# Rezoning Transportation Analysis

Petition Number: 2025-133

Date	Description
2-26-26	First Review (IW/KC)
4-23-26	Second Review (IW)
05-27-26	Third Review (TM)

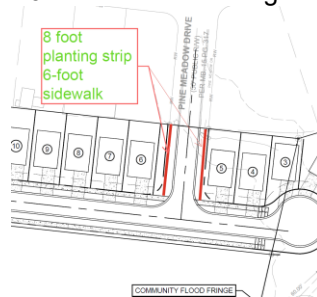
9. **Outstanding Comment From 4-23-26:** Revise site plan and conditional note(s) to commit to constructing 8-foot planting strip and 6-foot sidewalk along the Pine Meadow Drive extension.

**Clarifying Comment 05-27-26:** Revise site plan by showing an 8-foot planting strip and 6 foot sidewalk as committed to in the conditional notes and required by ordinance.

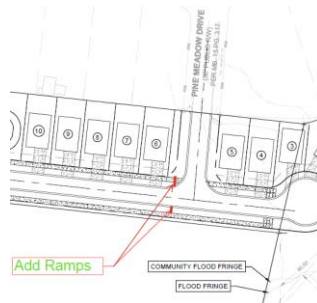
10. **Outstanding Comment From 4-23-26:** Revise site plan to commit to constructing curb ramps at the intersection of the new public roadway as well as the Pine Meadow Drive extension. Final design to be determined during permitting.

**Clarifying Comment 05-27-26:** Revise site plan by showing pedestrian ramps matching sidewalk width as shown in image above.
